**Application:** DCON(H)/09/1283  
**Location:** Land Nw Of Haverhill Anne Sucklings Lane Little Wratting Suffolk  
**Proposal:** Application to Discharge Conditions A2 (Alignment), A4 (Arboricultural Method Statement), A5 (Soft Landscaping) , A6 (Landscape and Ecological Management Plan), A8 (Archaeology) and A9 (Excavation and Ground Levels) of SE/09/1283

**A5 (Soft Landscaping) – Recommend further revisions**

As part of this condition, Detailed Hard and Soft Landscaping Proposals for Infrastructure Areas (Dwg ref: JBA17/364 01 to 13 Rev.J) have been submitted.

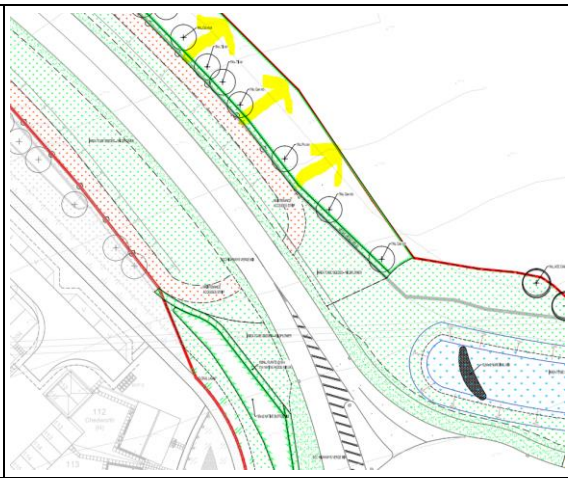
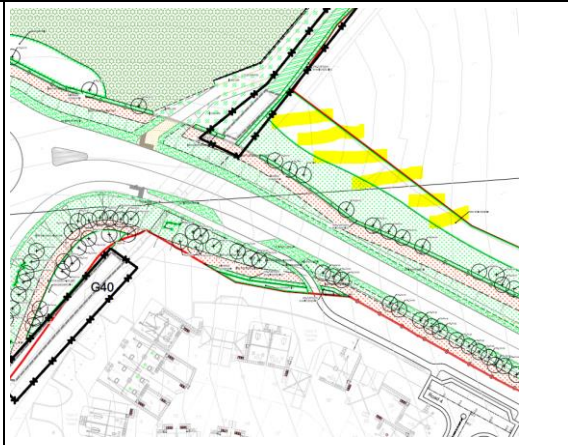
<p><b>Drawing ref: JBA17\3640 01</b></p> <p>This point is applicable along the length of the road but I've highlighted it on this plan. The hedge should be on the northern edge away from the road as previously discussed to mark the boundary with the adjacent agricultural fields.</p>	
<p><b>Drawing ref: JBA17\3640 04</b></p> <p>Woodland planting on area of yellow hatching would help to reduce visual impact of the roundabout on the surrounding countryside as roundabout is elevated.</p>	
<p><b>Drawing ref: JBA17\3640 04</b></p> <p>The amount of woodland planting to the north of the roundabout should be enlarged.</p>

**Drawing ref: JBA17\3640 05**

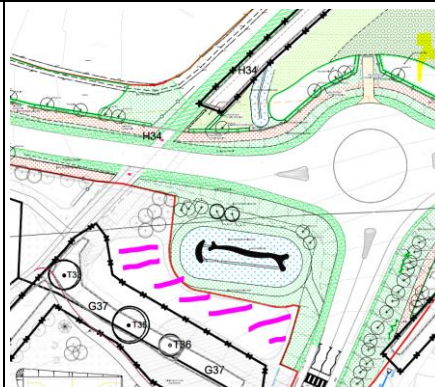
Same point as Drawing 04 regarding an increase in woodland planting north of the roundabout.

The masterplan also shows woodland planting on the southern side here (where basin is proposed). Could this be provided south of the basin (hatched in pink?) We understand this is outside the scope of the relief road DCON and would be in the infrastructure reserved matters but it is worth flagging up here if it is not possible to do in the road corridor due to the drainage requirements.

**Drawing ref: JBA17\3640 07**

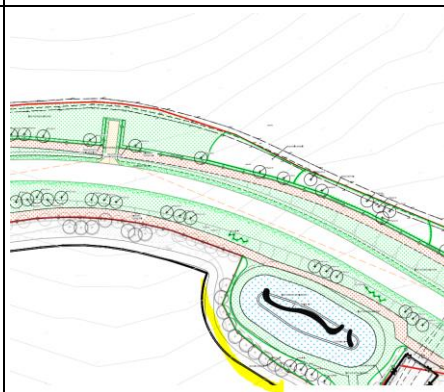
There should be some woodland to the south of the attenuation basin. I do not think this is going to be possible but could be provided in an alternative location (suggested an area on Drawing 4 east of the roundabout or Drawing 8 north of the road)

**Drawing ref: JBA17\3640 08**

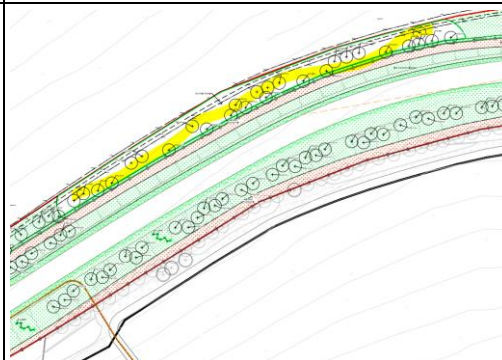
We note that some tree planting is included already. Though given the road will be elevated at this point, additional canopy cover could be included to increase levels of screening.

**Drawing ref: JBA17\3640 09**

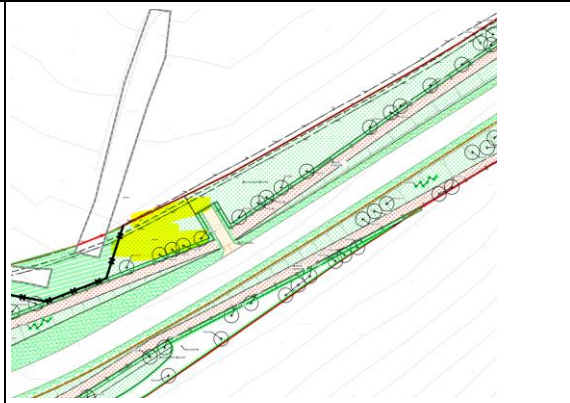
Additional woodland planting should be located here.
